Project	<b>IEEE 802.16 Broadband Wireless Access Working Group</b> < <a href="http://ieee802.org/16">http://ieee802.org/16</a> >	
Title	<b>Enhancement of Pre-authentication of PKMv2</b>	
Date Submitted	<b>2004-11-04</b>	
Source(s)	Chulsik Yoon, Mi-young Yun, and SungCheol Chang	<a href="mailto:csyoon@etri.re.kr">csyoon@etri.re.kr</a>
	ETRI 161, Gajeong-dong, Yuseong-Gu, Daejeon, 305-350, Korea	
Re:	Contribution on comments to IEEE P802.16e/D5	
Abstract	In this contribution, we propose to enhance the pre-authentication concept to the various cases of authorization modes.	
Purpose	Adoption	
Notice	This document has been prepared to assist IEEE 802.16. It is offered as a basis for discussion and is not binding on the contributing individual(s) or organization(s). The material in this document is subject to change in form and content after further study. The contributor(s) reserve(s) the right to add, amend or withdraw material contained herein.

# Enhancement of Pre-authentication for PKMv2

Figure 1. Description of the PKMv2 Key Hierarchy

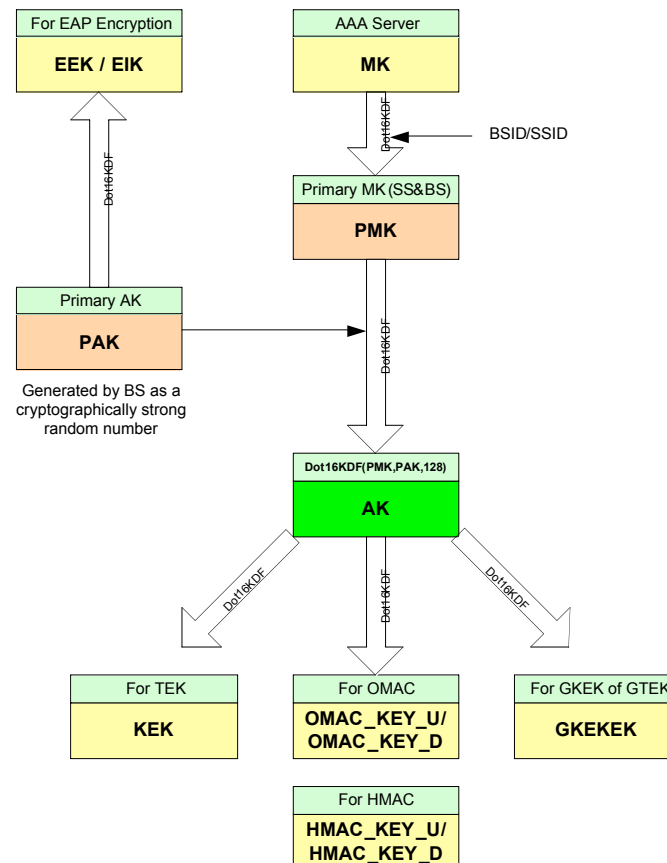
In Figure 1, I have shown the general PKMv2 key hierarchy concept.

Currently, the Pre-authentication is applied to the PMK, not PAK. In Figure 1, only the right branch of the key hierarchy tree can be applied the pre-authentication for fast handover. But for most of the cases including the left branch of the key hierarchy tree (the RSA only case, RSA with EAP yielding an MK case, and the RSA with EAP not yielding an MK case), the pre-authentication cannot be applied.

To enhance this mechanism to every case of the authentication mode, the MSS and the target BS shall share not only the MK, but also the PAK. During the HO procedure the serving BS transfer the MSS's capability information to the target BS, and then the target BS know the authorization capability of the MSS. Therefore, the MSS and the target BS can generate the same AK using the same AK generating rule for the initial network entry procedure, without PKM message transaction between them over the air.

If the target BS get the MK and the PAK, then the MSS and the target BS can derive the same AK between them using the MK, PAK, and SSID, BSID by the following step:
